Access Compliance Report

Public Rights-of-Way

Intersection ID: 10726	Main Street: AMBASSADOR_ST	Cross Street: STATE_ST	Location: E
ADA ID: 1445634F6561	Ramp Type: BlendTrans1	Initial Pass/Fail: Pass	Overall Compliance: No
		Severity Score: 7.5

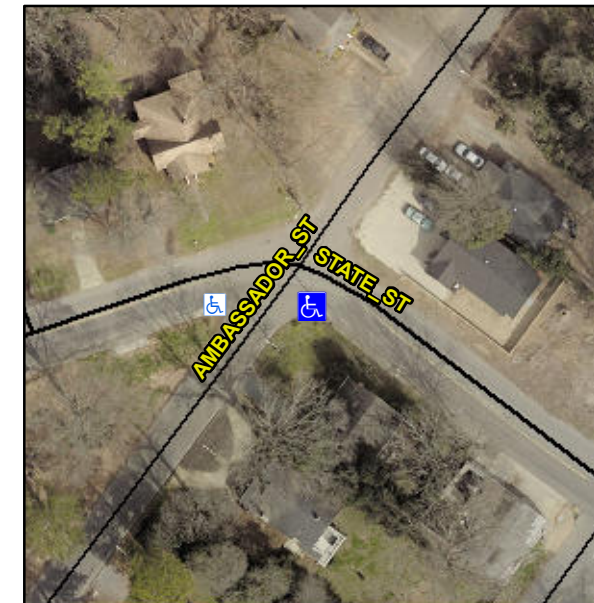
R304.2.1, R305.1.4, R305.2, R304.5.4, R304.5.3

Compliance	Description	Data	Compliance	Description	Data
N/A	Ramp Length (in)	31.0	Yes	BlendTrans Slope (%)	3.1
Yes	Ramp Width (in)	48.0	Yes	BlendTrans XSlope (%)	0.2
N/A	Flare Type LT	None	N/A	Flare Type RT	None
N/A	Flare Slope LT (%)	N/A	N/A	Flare Slope RT (%)	N/A
N/A	Flare Traversable LT?	N/A	N/A	Flare Traversable RT?	N/A
No	Landing Length (in)	41.5	Yes	DWS Provided?	Yes
Yes	Landing Width (in)	48.0	Yes	DWS Contrast?	Yes
Yes	Landing Slope (%)	0.1	Yes	DWS Length (in)	25.0
Yes	Landing X Slope (%)	0.6	No	DWS Full Width?	No
N/A	Landing Curb? (Y/N)	No	No	DWS Offset (in)	6.0
N/A	Shared Landing?	Yes			
Yes	Gutter Ponding?	No	No	Gutter Slope (%)	9.5
Yes	Gutter Lip Ht (in)	0.0	No	Gutter X Slope (%)	5.4
N/A	Painted X Walk1?	No	N/A	Painted X Walk2?	N/A
	X Walk 1 Direction	To W		X Walk 2 Direction	N/A
	X Walk 1 Width (in)	N/A		X Walk 2 Width (in)	N/A
	X Walk 1 Slope (%)	7.6		X Walk 2 Slope (%)	N/A
	X Walk 1 X Slope (%)	5.5		X Walk 2 X Slope (%)	N/A

N/A	Ramp inside XWalk1?	N/A	N/A	Ramp inside XWalk2?	N/A
	Road Slope (%)	5.5		Clear Space?	Yes
	Road X Slope (%)	7.6	N/A	Clear Space to XWalk (in)	N/A
Yes	Any Obstructions?	No	Yes	Storm Grate/Utility Hazard?	No
	Obstruction Type			Storm Grate/Utility Type	
		N/A			N/A
			Yes	Surface Condition? (G/P)	Good
			Yes	Curb Slope (%)	1.0

Remove & Replace Curb Ramp With Two New Directional Ramps or Equivalent. Remove & Replace Gutter.
